APPLICATION NO.	FILING DATE	FIRST NAMED INVENTOR	ATTORNEY DOCKET NO.	CONFIRMATION NO.
09/748,277	12/27/2000	Jae-Lag Ma	8733.363.00	4729

Office Action Summary

DETAILED ACTION

FIG. 3

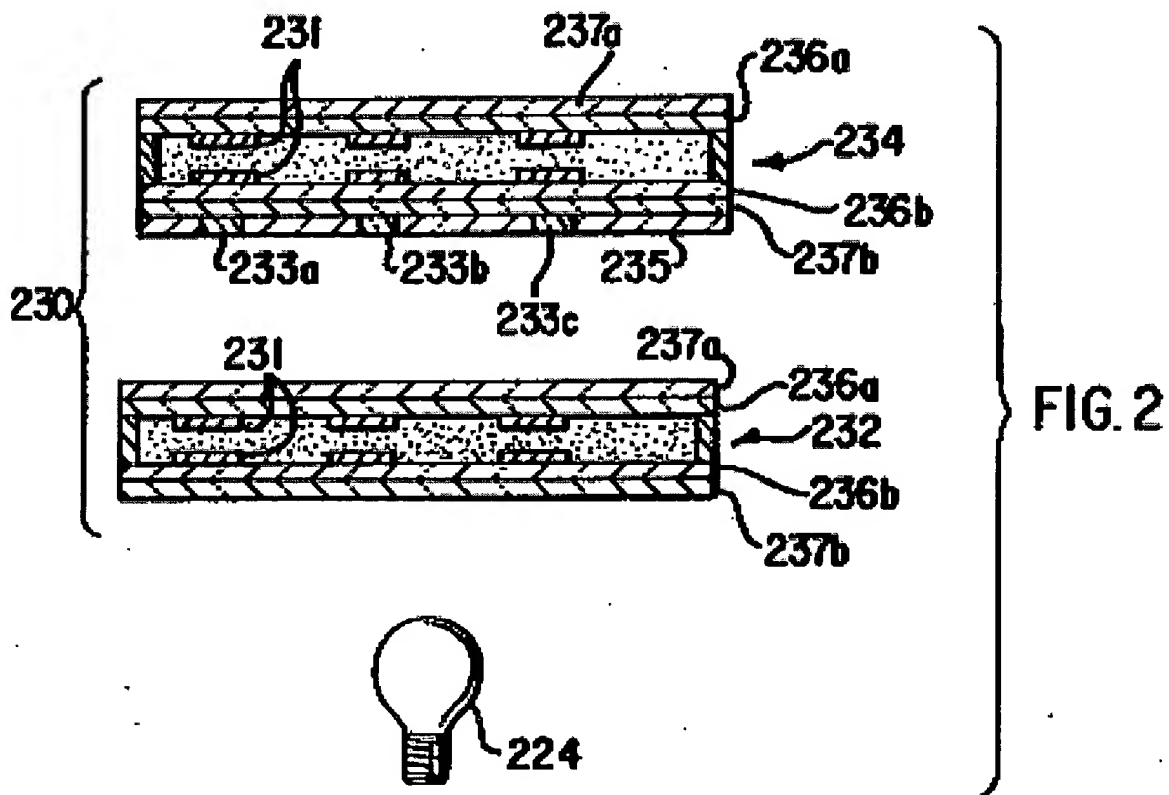
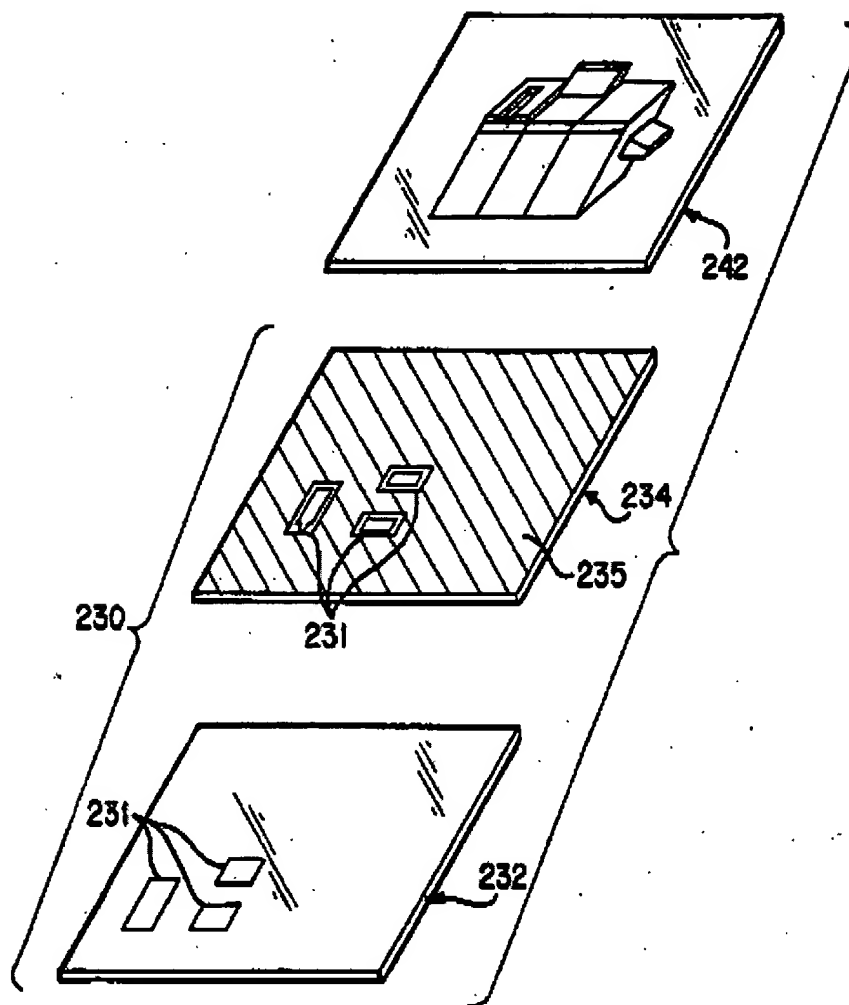
As to claims 6, 9, 10, and 11, Dingwall teaches in Figures 2 and 3 (col. 5, lines 33-40 and col. 7, line 60 through col. 8 line 28), a liquid crystal display (LCD) device, comprising:
an upper polarizer, 237a; on an upper substrate, 236a;

a lower substrate, 236b, on a lower polarizer, 237b, (Applicant's redundant lower substrate); a liquid crystal layer disposed between the upper substrate and the lower substrate; and a backlight device, 224, disposed opposite the lower polarizer for emitting light toward the lower polarizer (Figure 4);

wherein the lower polarizer includes at least one opaque surround or black mask, 235, (Applicant's light shielding film) in a peripheral portion, formed in the four peripheral sides of the lower polarizer (as illustrated in Figure 3) wherein the black mask absorbs light (col. 8, lines 29-33, and col. 13, lines 25 and 26).
